Platt Technical High School

ADDENDUM NO. 4

August 9, 2019

SECTION R1
SCALE: 3/4" = 1'-0"

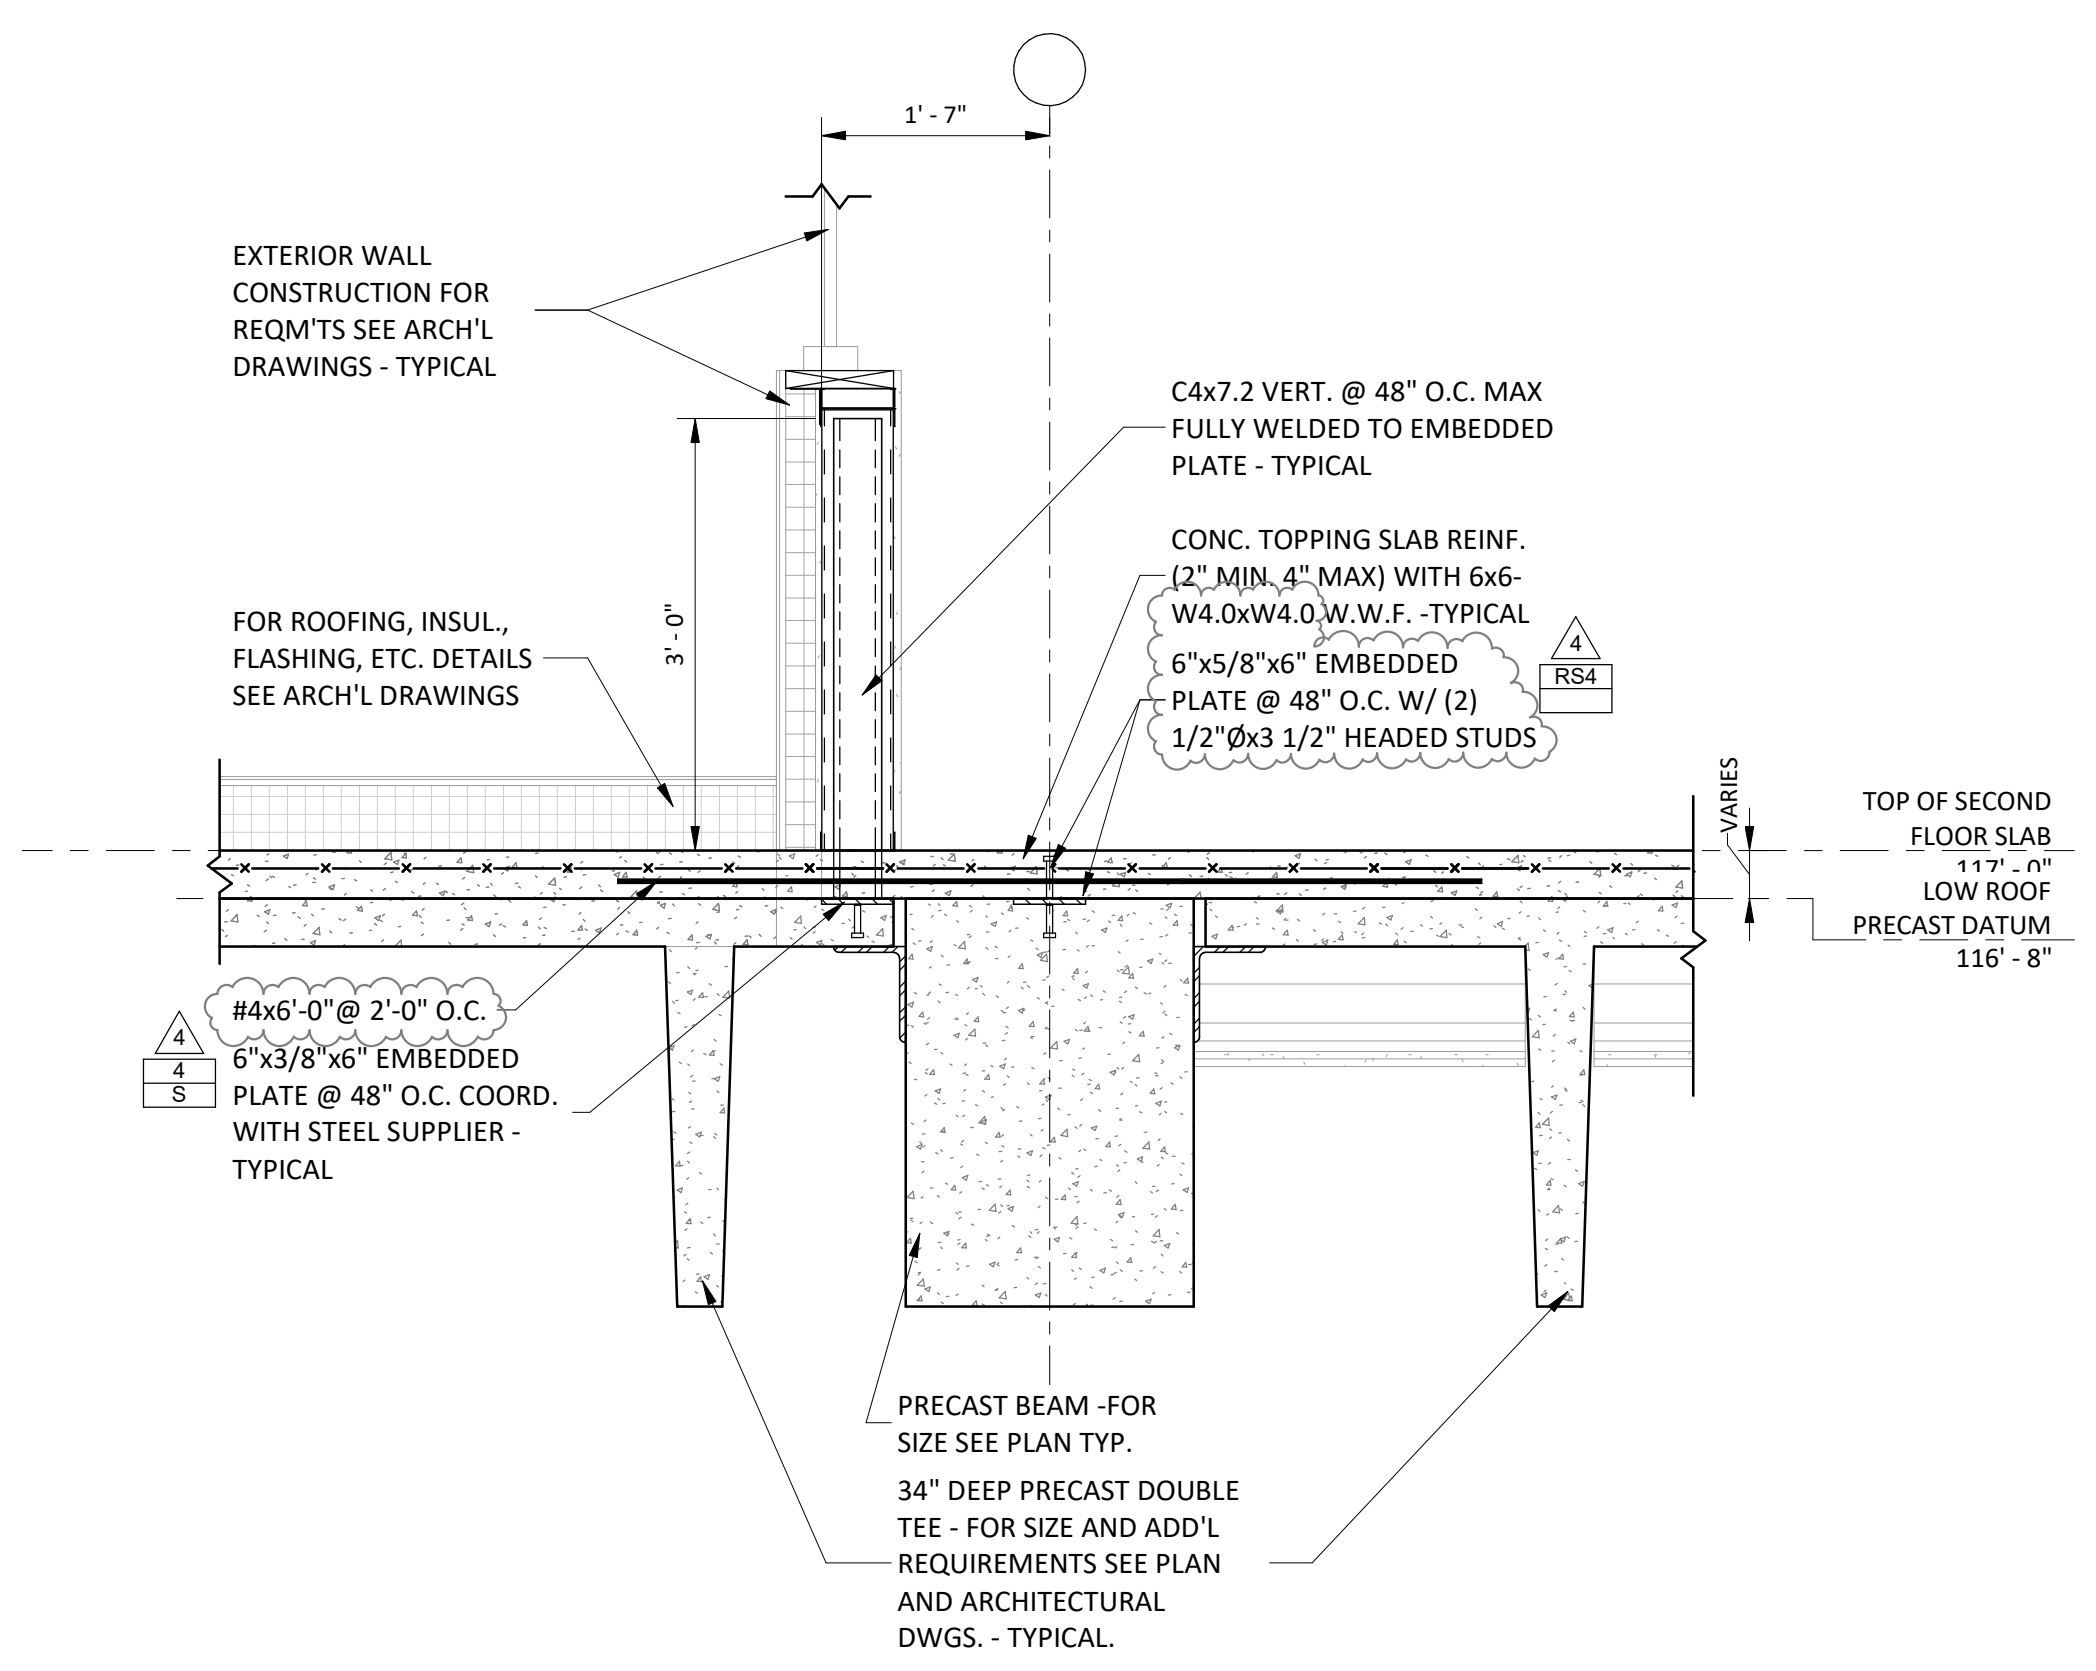
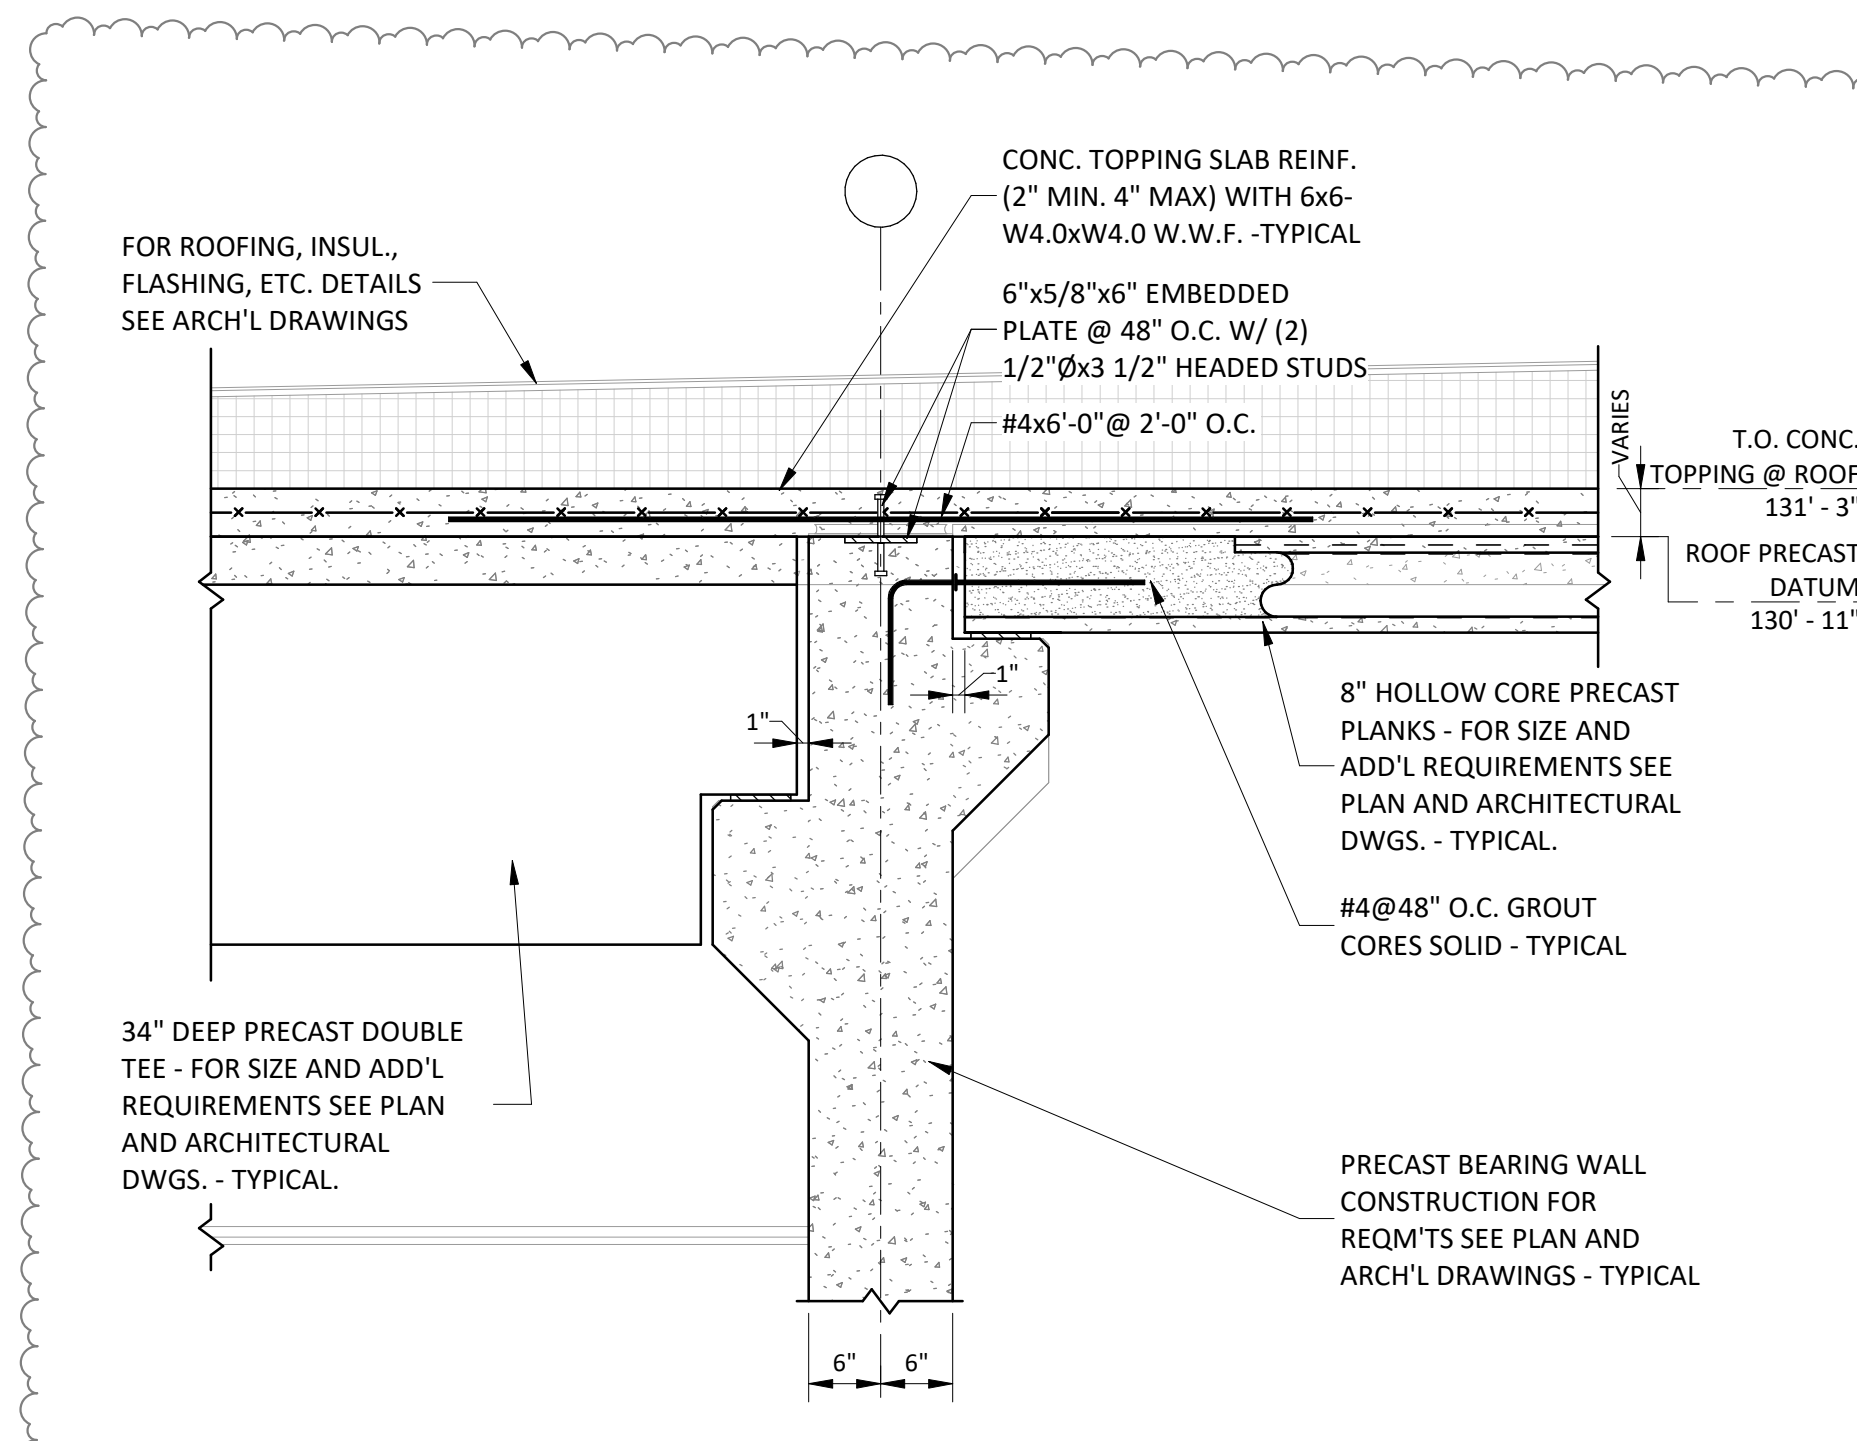
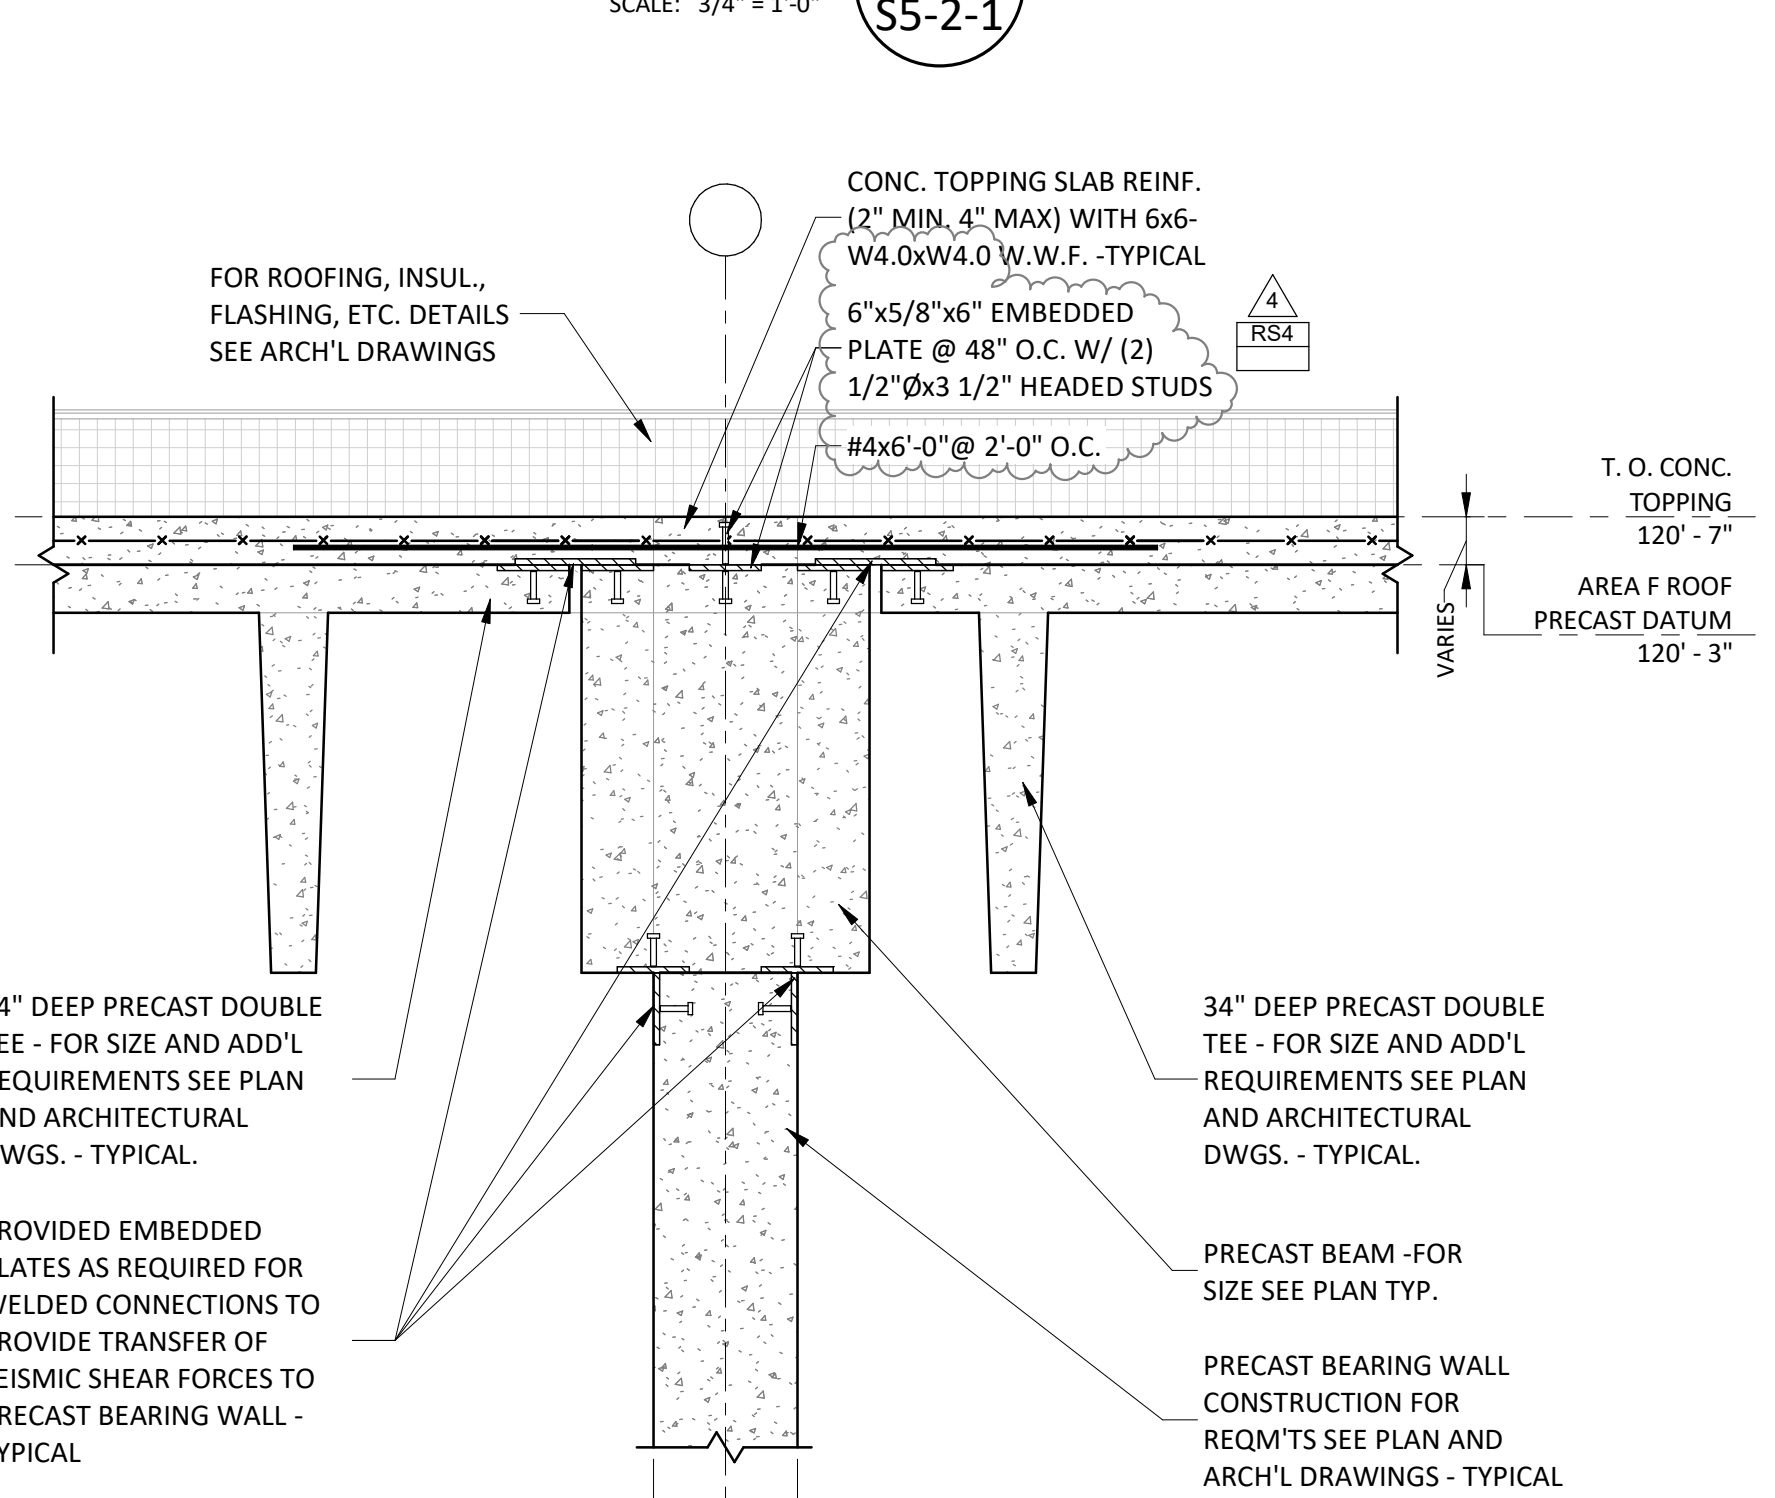
- ADD 4-130 DRAWING S5-2-1– STRUCTURAL SECTIONS**
Revise topping reinforcement per Revision RS4-39.
- ADD 4-131 DRAWING S5-2-2– STRUCTURAL SECTIONS**
Revise topping reinforcement per Revision RS4-40.
